DNAA /AMC REVIEW OF THE DRAFT TERRITORY PLAN

Issue: 3

Date: 27th Feb 2023

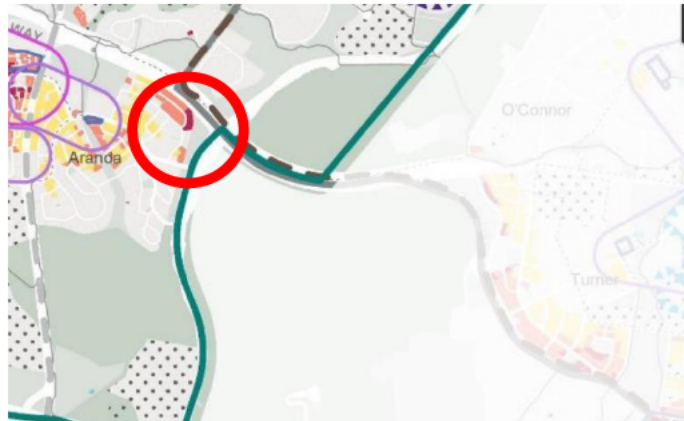
- Why was the Strathnairn Suburb the only suburb identified in the Belconnen district specification?
- Using this excerpt from the Belconnen District Strategy, there are some areas of potential redevelopment which appear to be examples of “plonkism” where a high density development is suddenly a possibility in Aranda without a broader argument or logic over and above the light rail. There is a similar situation in Turner as below. I guess its trying to understand the depth of the thinking behind the plans and therefore industry / community needing more time to scrutinize each district strategy
